241-C-102, 241-C-104, 241-C-107, 241-C-108, and 241-C-112 Tanks Waste Retrieval Work Plan

Tank Operations Contractor (TOC) RECORD OF REVISION		(1) Document Number: RPP-22393		Page <u>1</u>
(2) Title: 241-C-102, 241-C-104, 241-C-107, 241-C-108, and 241-C-112 Tanks Waste Retrieval Work Plan				
Change Control Record

241-C-102, 241-C-104, 241-C-107, 241-C-108 AND 241-C-112 TANKS WASTE RETRIEVAL WORK PLAN

Figure A-1. Tank C-102 Technetium-99 Risk Plot.

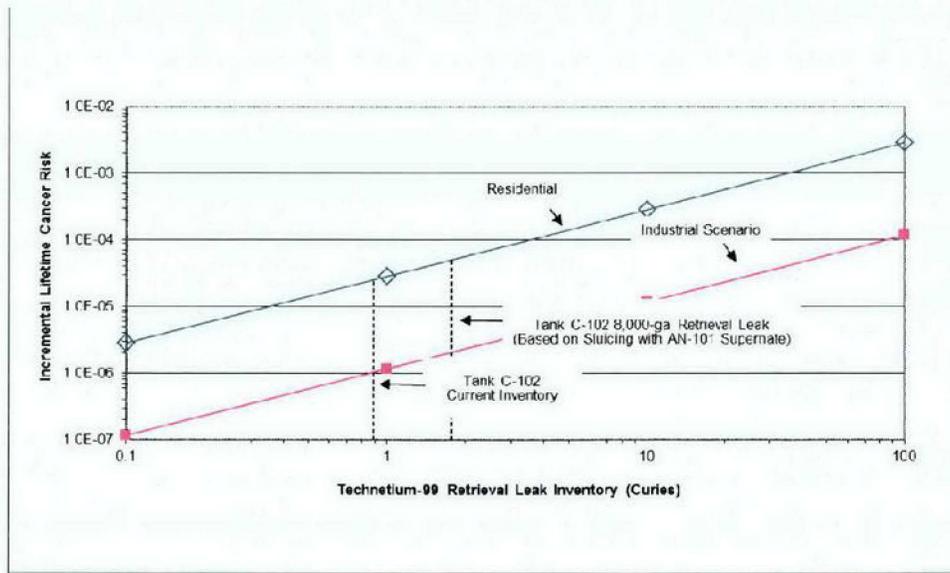
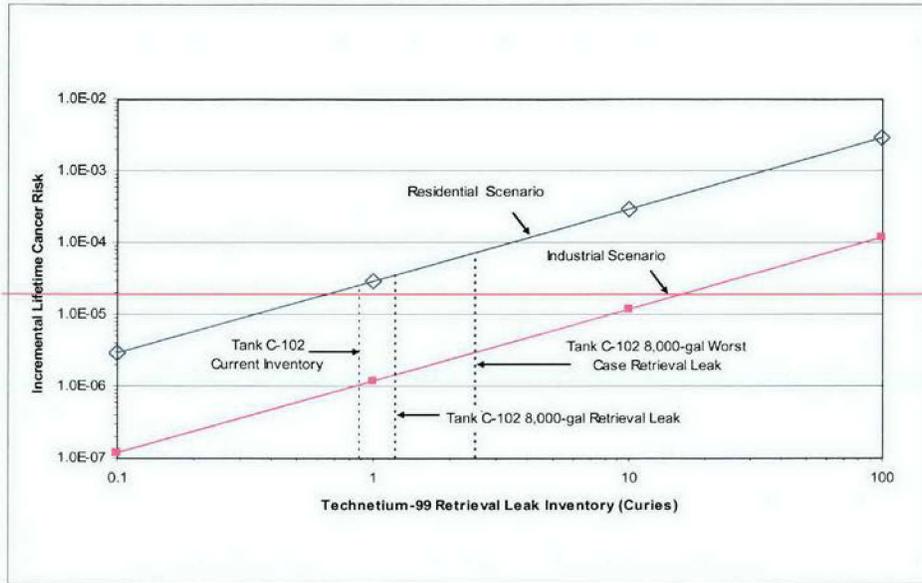
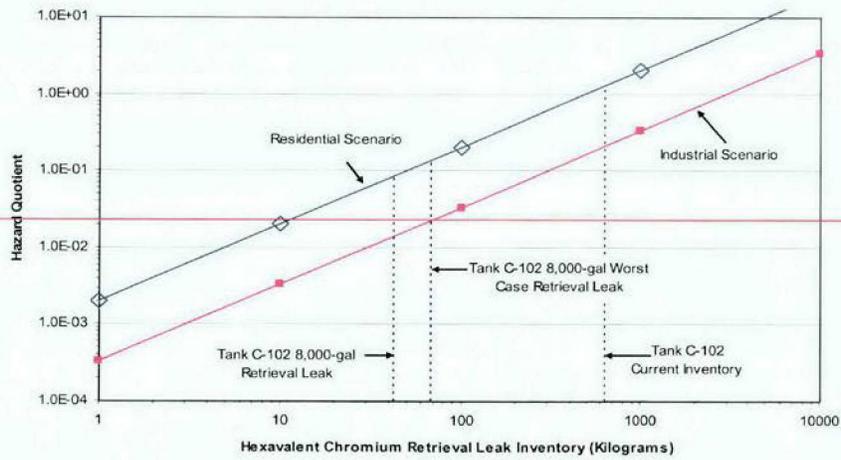
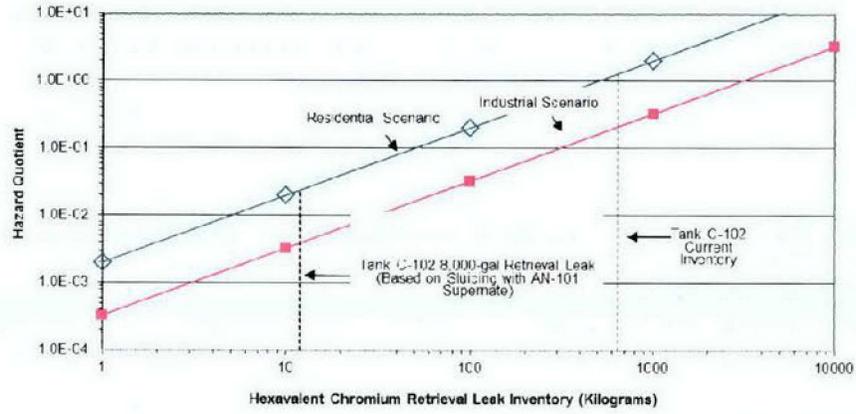
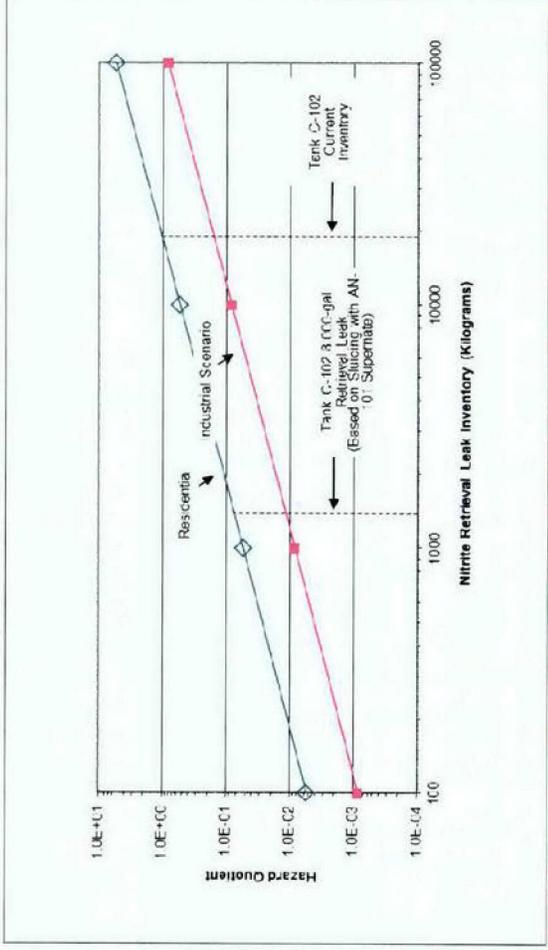
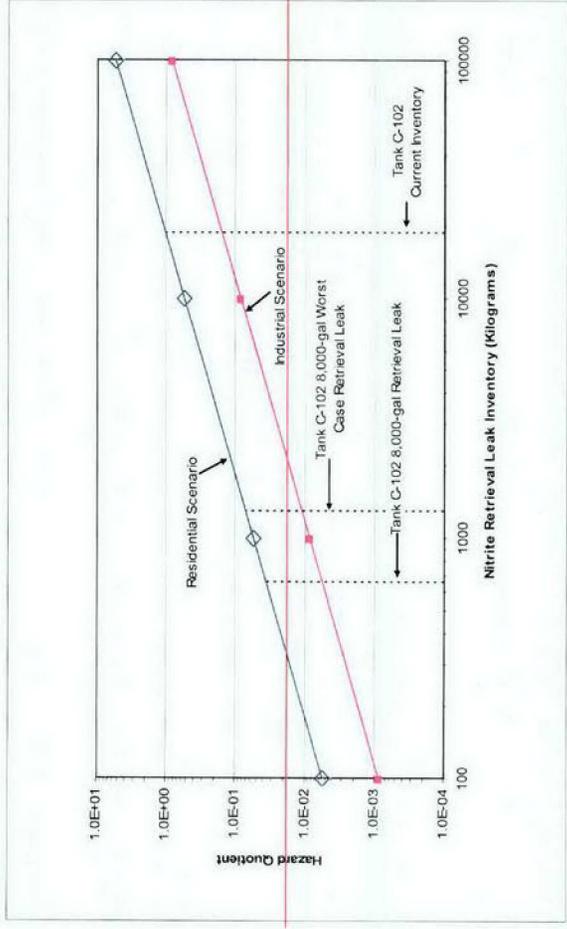
9. Description and Justification of Change: Change Description: RPP-22393, Rev 5, Appendix C, uses an AN-106 supernate nitrite concentration of 2.55 E+04 mg/L for a leak during retrieval. This number is increased to 3.2 E+04 mg/L. This 25% proportional impact will be reflected on Figure C-3, in Table C-1, and in Section C2.3. Justification: The current concentration assumes the C-108 heel is retrieved into AN-106 before C-107 retrieval. Recent schedule changes now show C-107 retrieval may precede C-108 retrieval. Without the C-108 liquid addition to AN-106 the higher current AN-106 nitrite concentration is conservatively assumed for a leak.
